#### COMMENTS OF THE STAFF OF THE CALIFORNIA PUBLIC UTILITIES COMMISSION

### ON THE DRAFT 2016-2017 TRANSMISSION PLAN FOLLOWING THE FEBRUARY 17, 2017 STAKEHOLDER MEETING \*\*\*\*\*\*

#### March 7, 2017

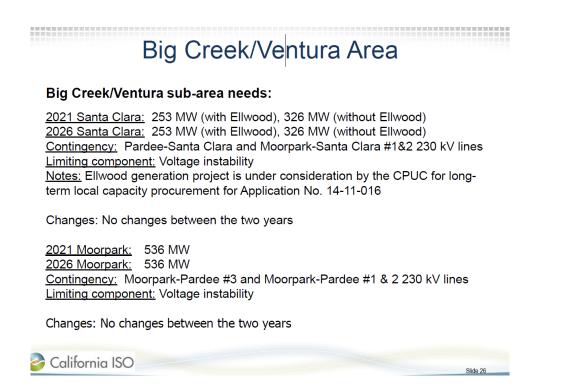
However, in its presentation on this study February 17, 2017, CAISO indicates that the need is 253 MW (with Ellwood) and 326 MW (without Ellwood), as shown in CAISO's presentation slide below. Energy Division staff believe that CAISO should update its "Final" 2021 LCR study to explain this assumption, otherwise it could be mistakenly assumed that the need is 326

MW in all circumstances. Moreover, CAISO should clearly explain in its study, why the need changes depending on whether Ellwood is assumed in the study and not (i.e., why the need is not constant, irrespective of available resources).
